2000P07639US01; 60,427-252

REMARKS

CLAMPLESS HOSE RETAINER MECHANISM
Applicant: Stuart; Serial N. 09/838,472
REPLACEMENT SHEETS

Fig-2

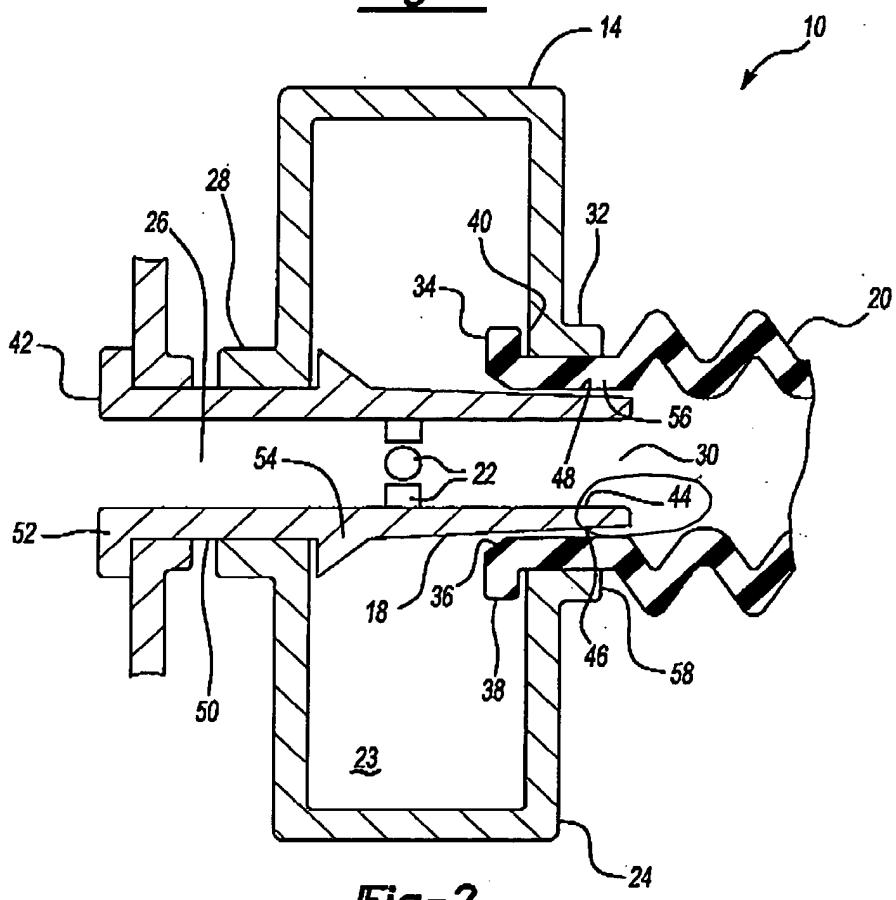
Figures 2 and 3 have been amended. The line extending from reference numeral 44 in Figure 2 has been shorted to point to the tapered insertion end, as described in the specification. The reference numeral 137 pointing to the angled face of the tube 120 has also been changed to "136." Applicant is filing revised formal drawings reflecting these changes with this Amendment.
